City of Richmond

Report to Committee

To: General Purposes Committee **Date:** November 3, 2022
From: Mark Corrado **File:** 12-8350-05-AMANDA
 Director, Community Bylaws & Licencing #/Vol 01
Re: **Soil Use for the Placement of Fill Application for the Property at 22040 River Road (Thandi)**

SOIL PLACEMENT PLAN

Figure 1: Proposed new soil profile

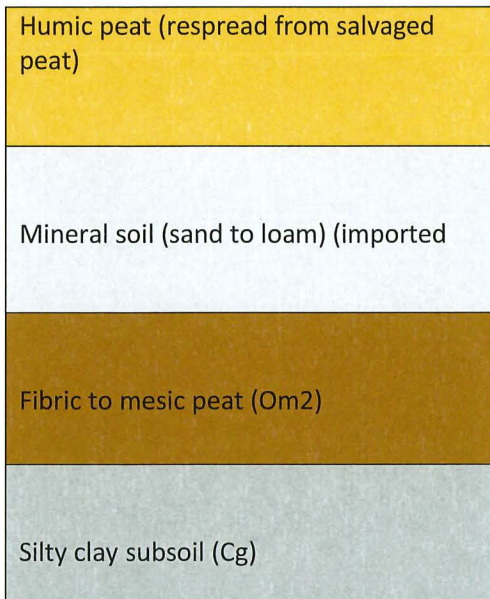
The creation of the layered soil will cause a break in the soil capillarity which may result in increased soil drying in the organic (peat) topsoil.

With only 40 cm of peat as a topsoil and the increased drying due to the break in the capillarity there will be a significant increase in oxidation of the peat, resulting in subsidence (shrinkage of the topsoil). This topsoil layer could disappear very quickly leaving the fill layer to farm.

The report should address the above issues as they will have long term consequences to the ability to farm the property.

I have reviewed the report dated November 1, 2021 2nd Revision. This report deals with the issues that I identified in my memo of September 26, 2019. Specifically, the proposal is now to strip all the organic soil add appropriate fill and then replace the organic soil. This will eliminate the compression of the organic soil and make it easier to manage organic soil subsidence.
